### PLANNING BOARD AGENDA Tuesday, November 30, 2021 @ 7:00PM

**TO:** Planning Board Members  
**FROM:** Alaa Abusalah, Town Planner  
Brooke Hultgren, Department Assistant  
**DATE:** November 29, 2021  
**RE:** **Planning Board Applications – November 30, 2021**

### **SP2021-08, 1603 – 1605 Main Street – Skaff Fuels Inc.**

Site Development Plan  
at  
#1603 - #1605 Main Street  
Leicester, Massachusetts

**SITE LAYOUT PLAN**  
For  
#1603 - #1605 Main Street  
in  
Leicester, MA

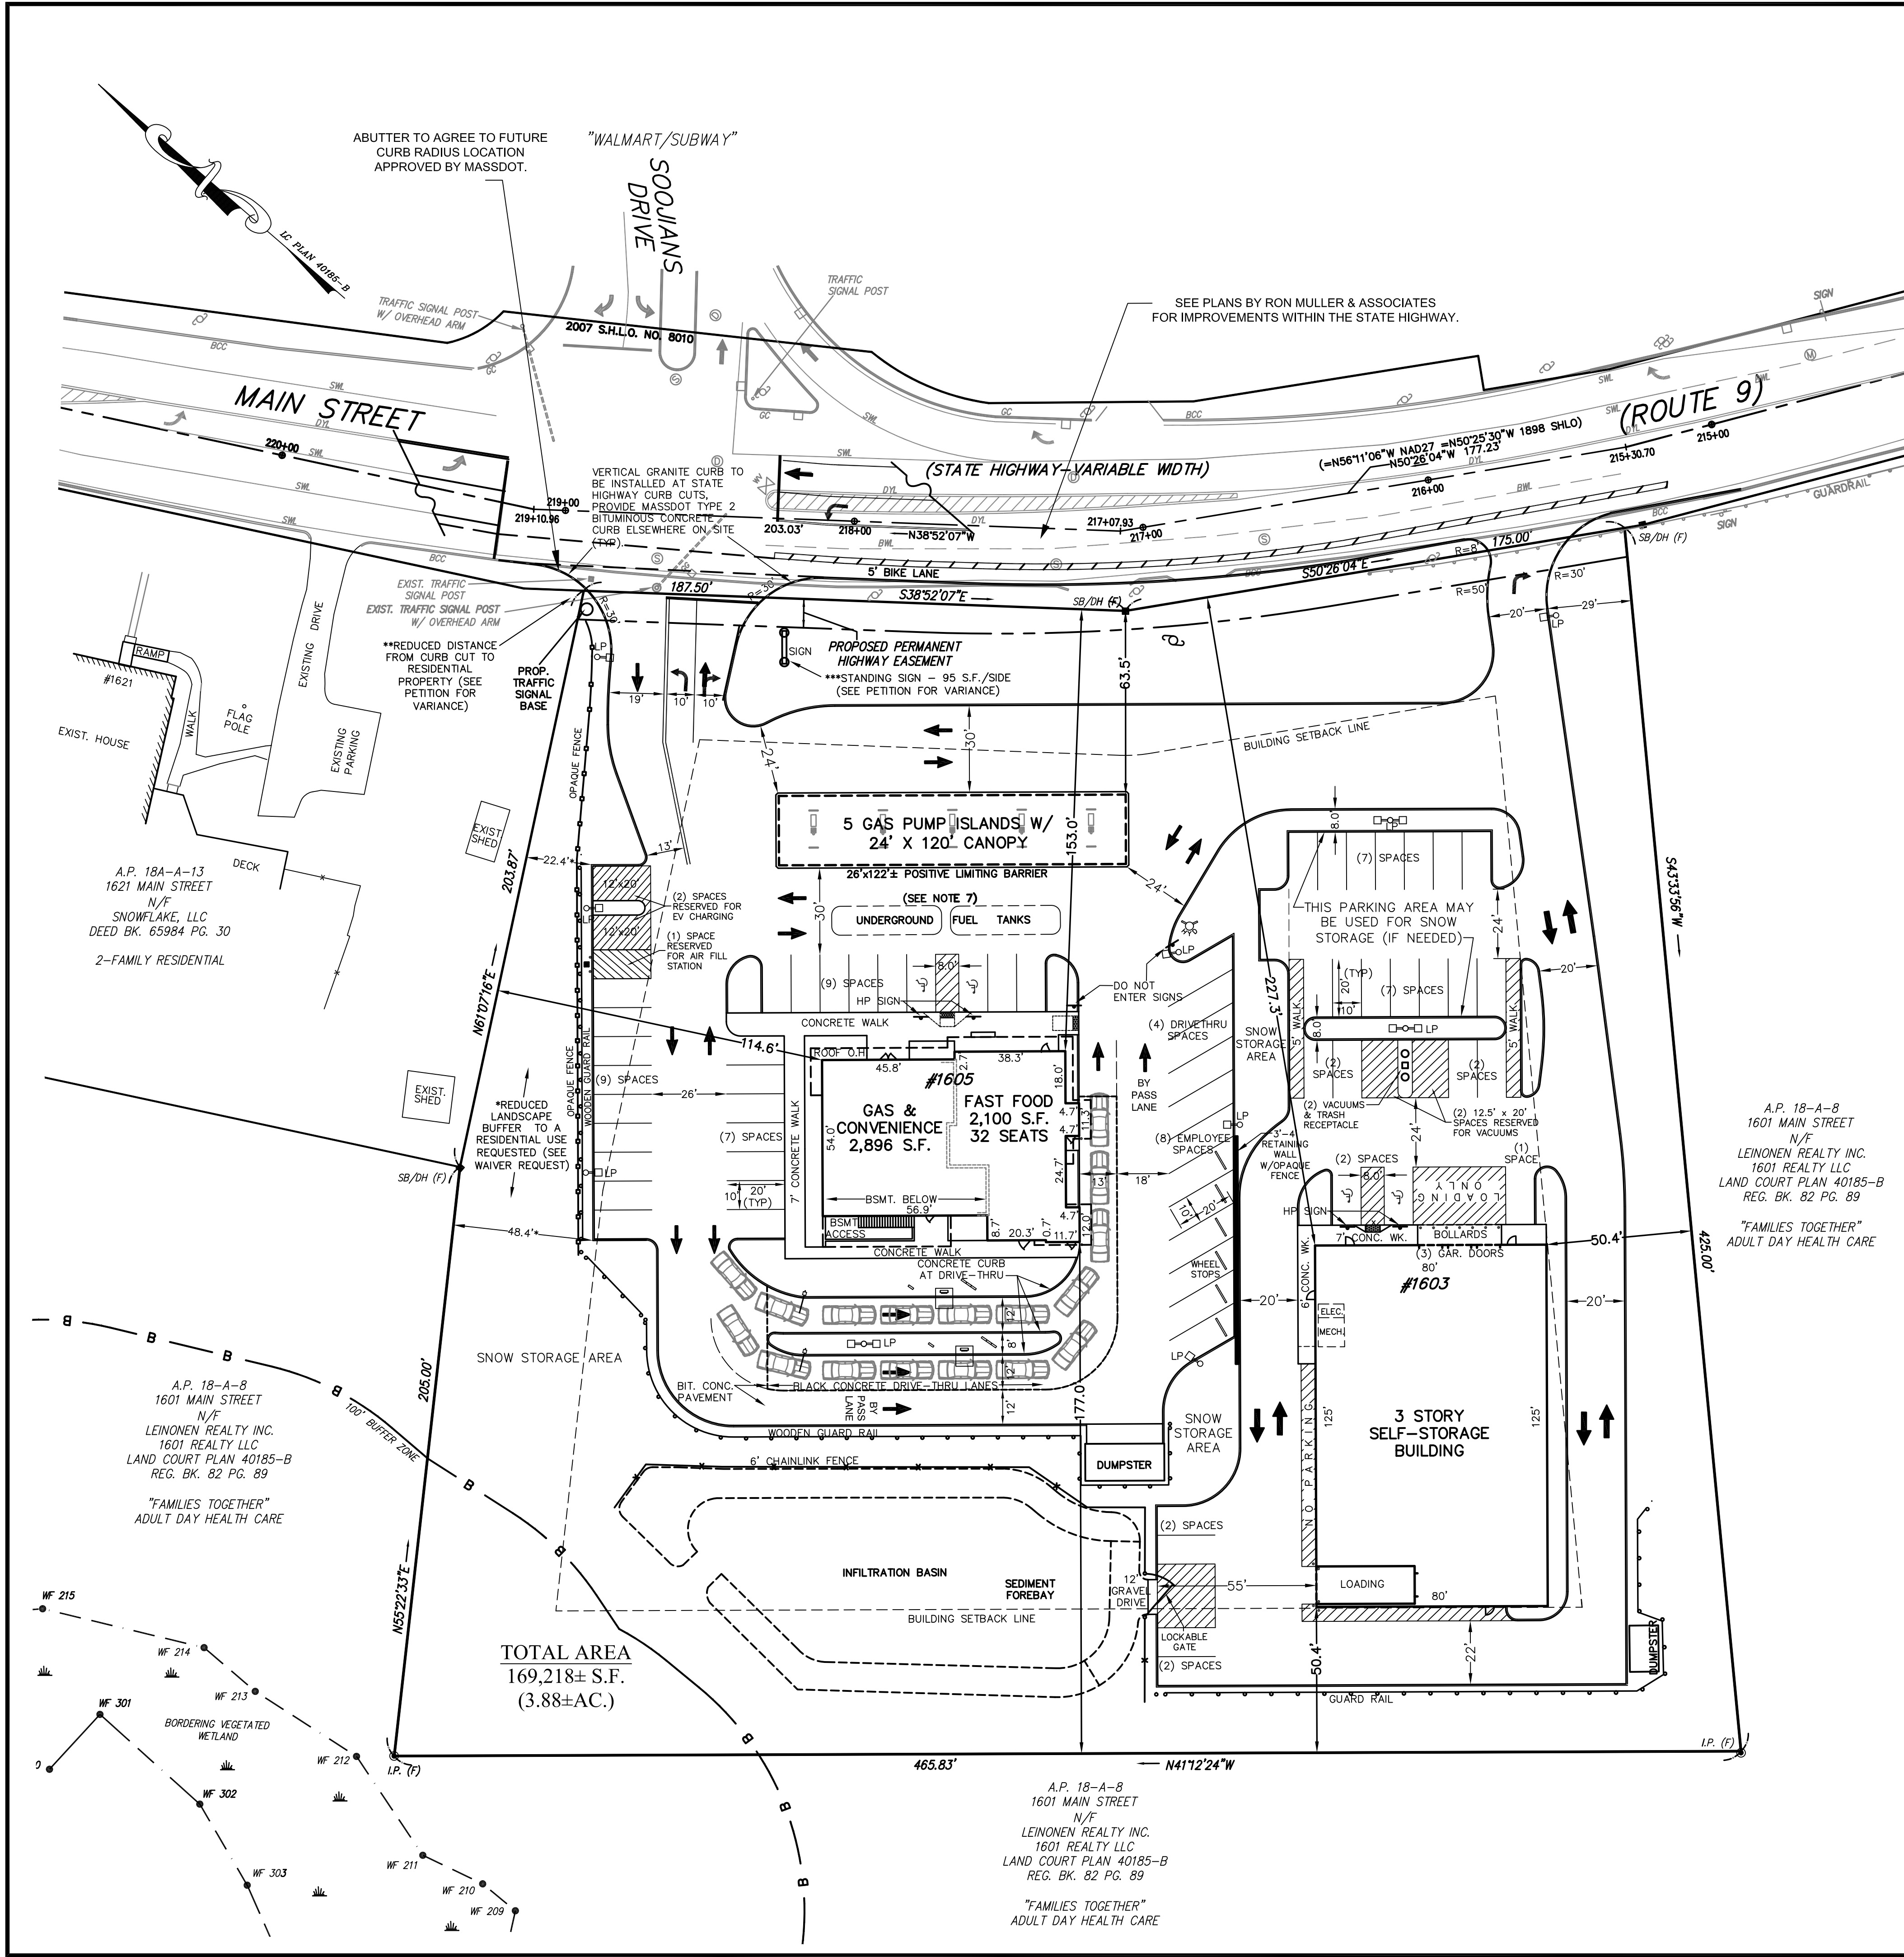
**No further comment.**
9. The waiver requested from §5.5.02.2.B specifies a buffer width of 48.4 feet. The Applicant should also reference the minimum buffer width proposed in the waiver request.

10. Parking is proposed on the western side of the property within the area that would typically be designated as a landscape buffer. This office defers to the Board if a waiver from §5.5.02.2.H should be included in the waiver requests. Parking was not in this location on the previously approved plan.

25. The proposed dumpster location at #1605 Main Street will require a front loading trash truck to drive the wrong way against the traffic flow. The Applicant should clarify the trash removal

**Resolved with comment.** *AEA has indicated that trash removal is usually scheduled during off peak hours and that a rear loading truck could proceed with traffic, back up and load.*

*Ultimately, it is the responsibility of the Applicant/Owner to provide a system of trash removal for this private site that is effective and minimized disruptions.*

**PRECAST CONCRETE DIVERSION MANHOLE**  
(NOT TO SCALE)

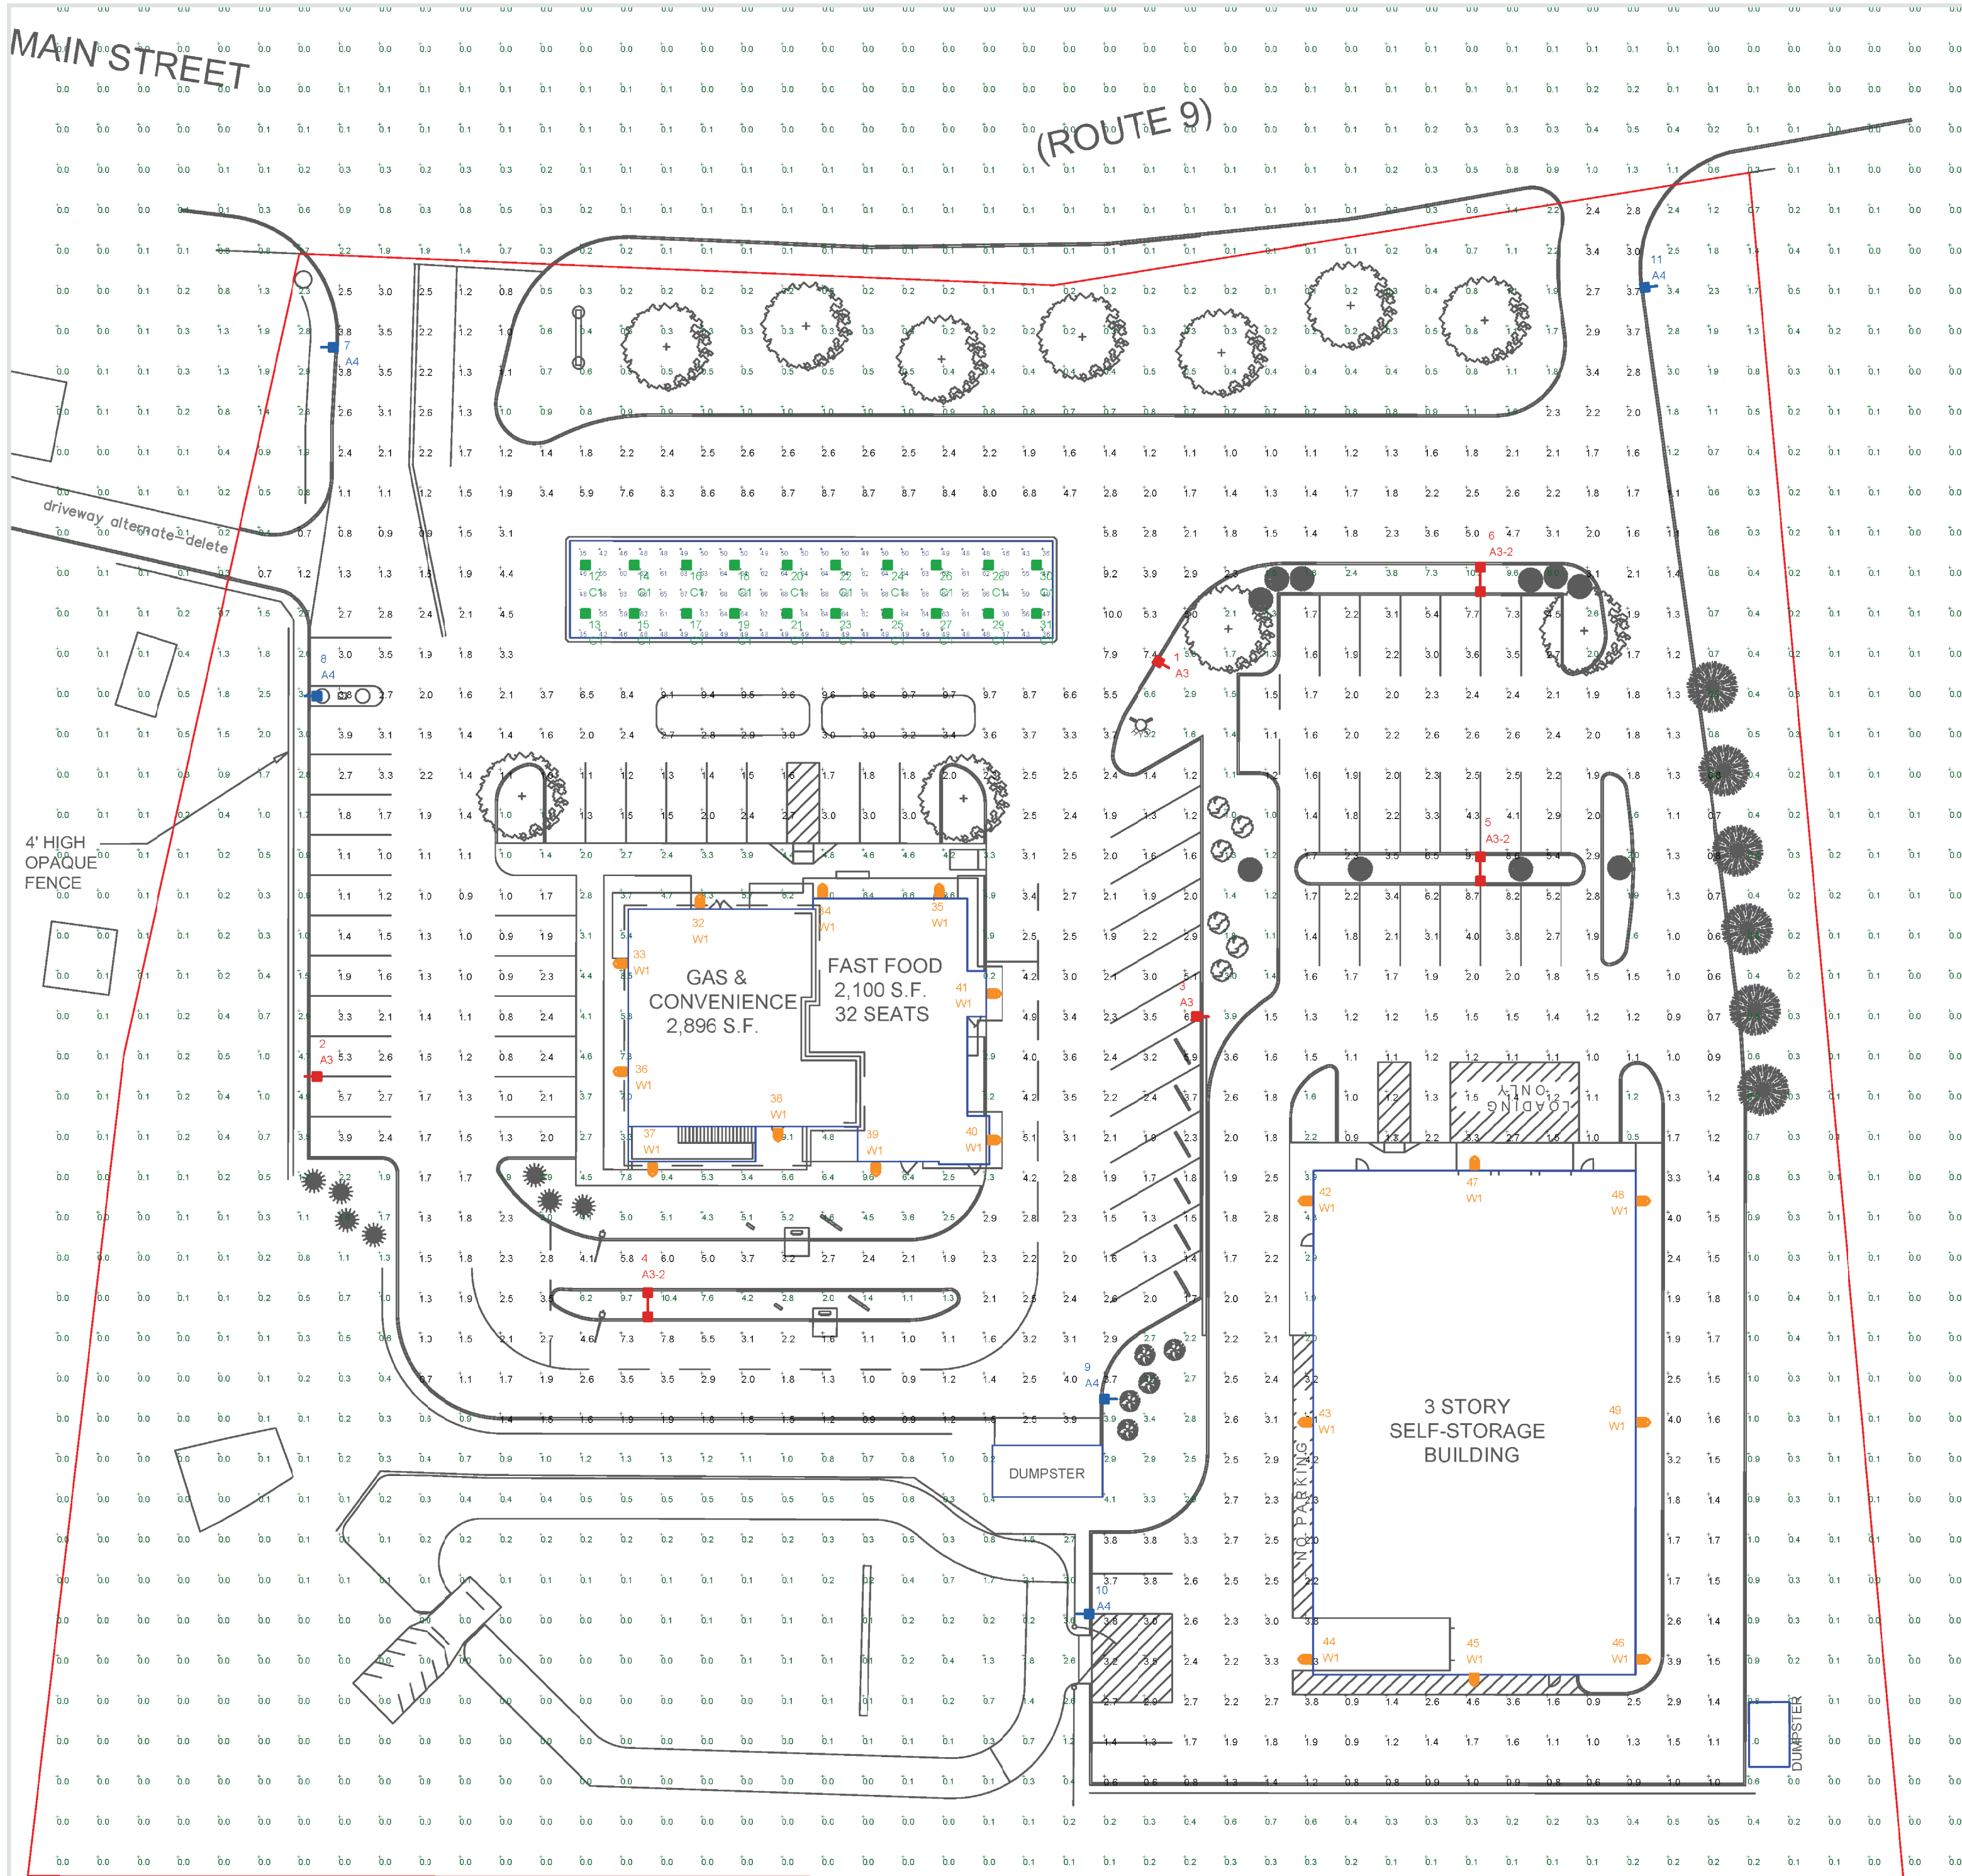
34. The weir elevation and inlets/outlet elevations must be labeled in the diversion manhole detail.

LIGHTING  
PHOTOMETRIC PLAN

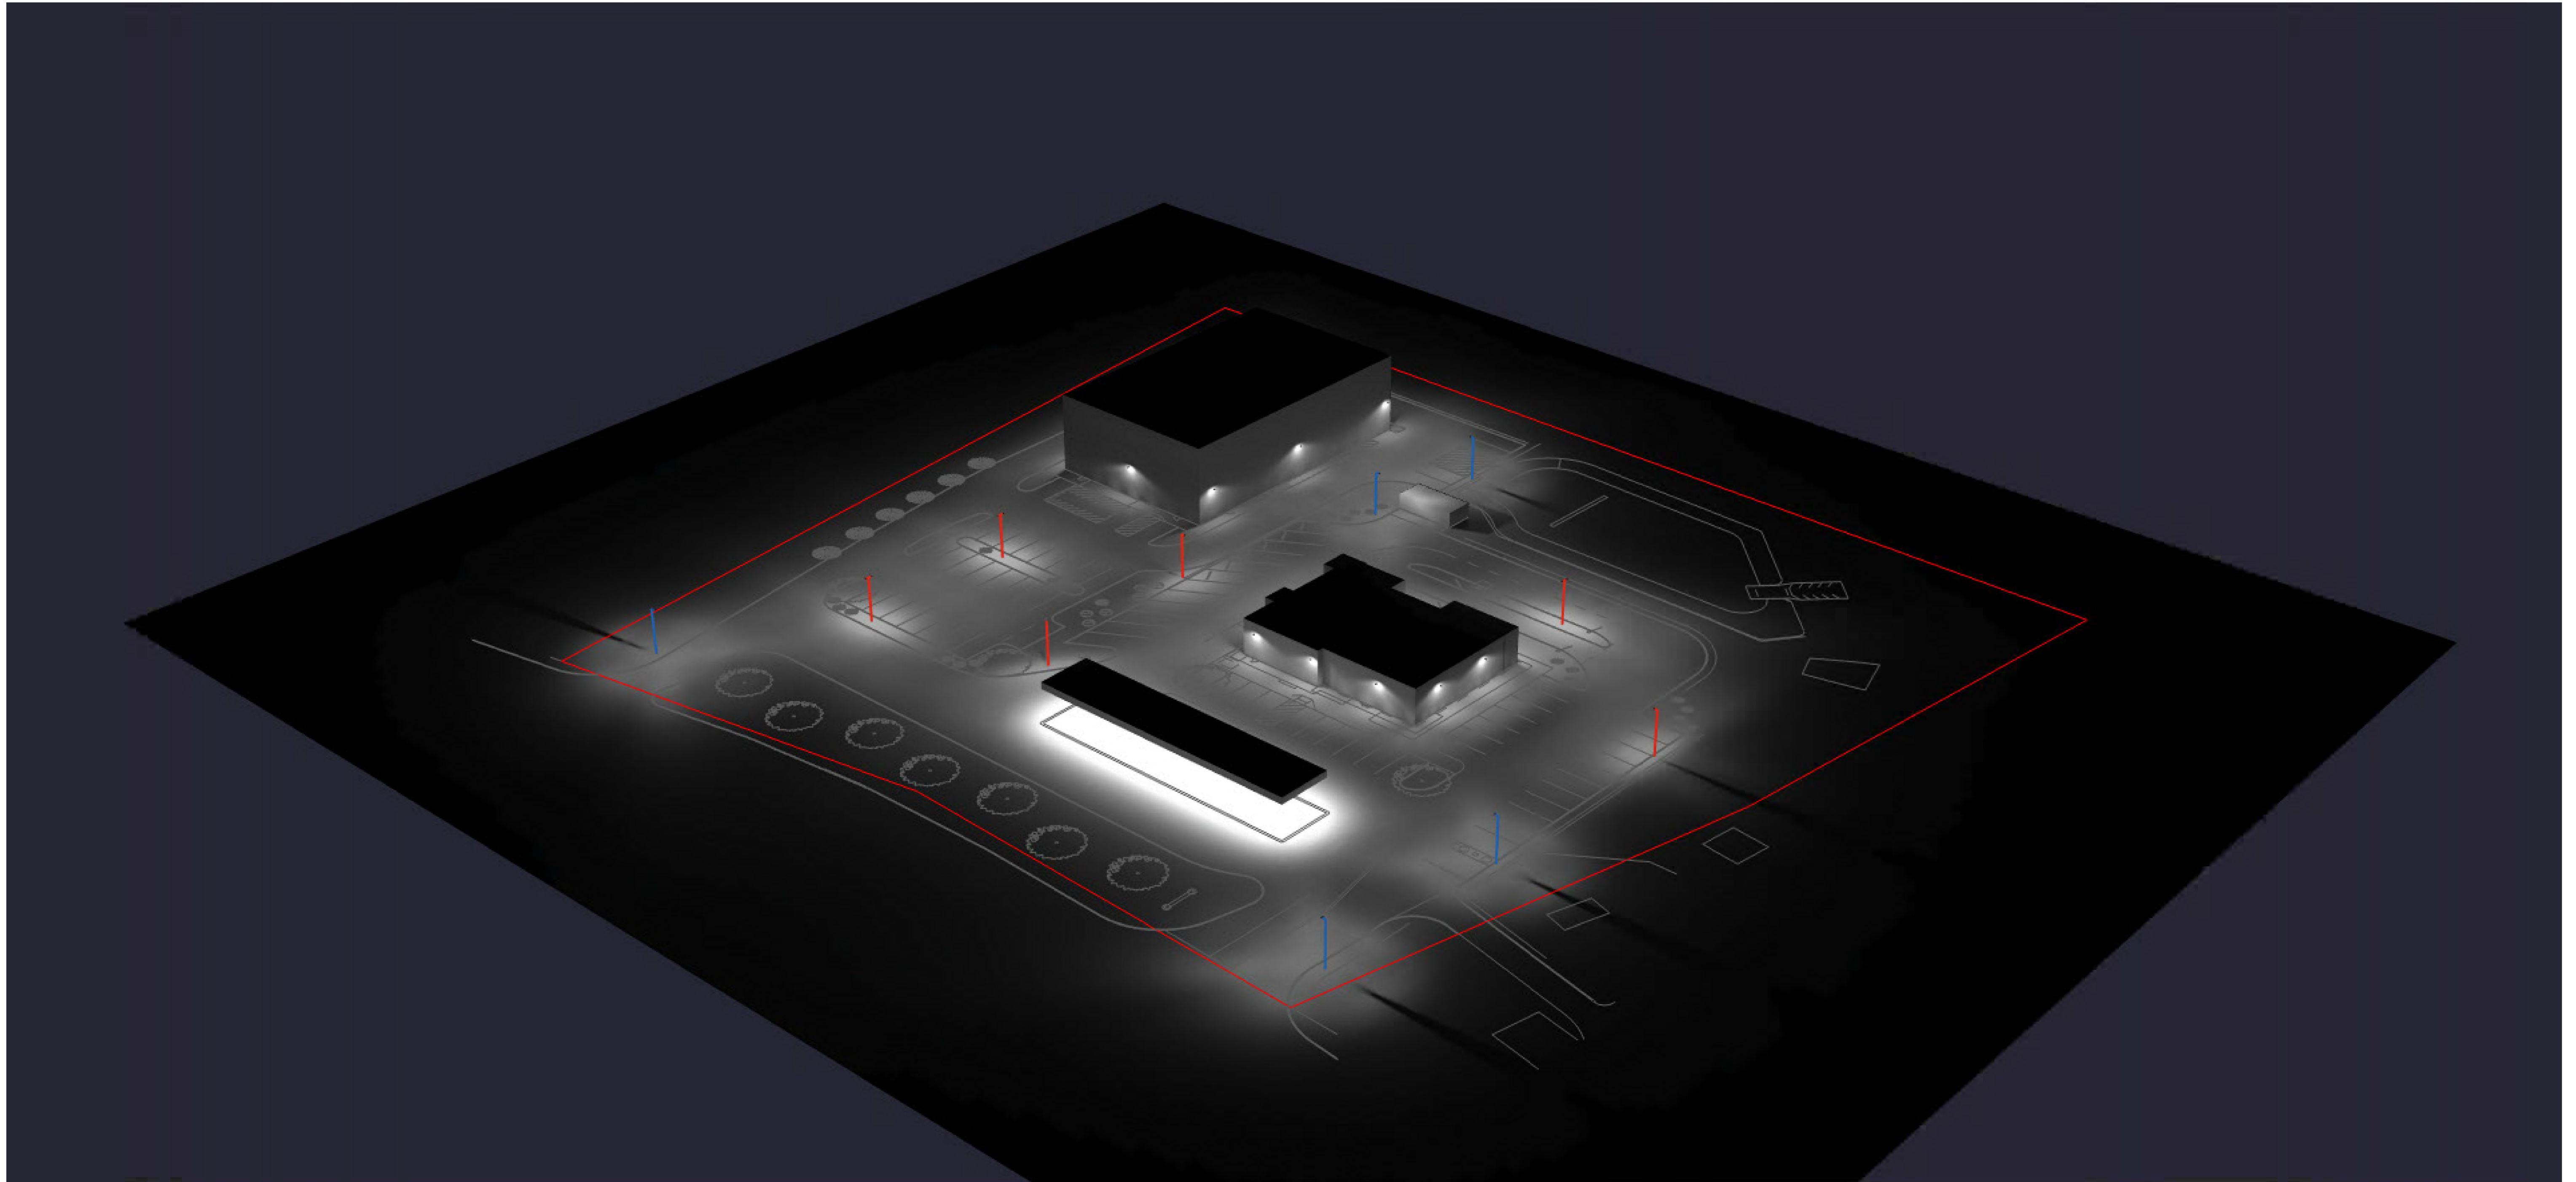
5. The submitted photometric plan identifies light spillage over 1 foot-candle on the adjacent property. The Applicant must demonstrate that lighting does not shine beyond the property lines. (§5.5.02.1.A.7 and LPR IV.G)

*AEA has deferred to the Board and has indicated that the regulations do not provide a maximum foot-candle measurement. It should be noted that Section 5.5.02.1.A.7 states that lighting shall not shine beyond the property lines. It is recommended that the proposed lighting be revised to eliminate the lighting that extends beyond the property lines.*
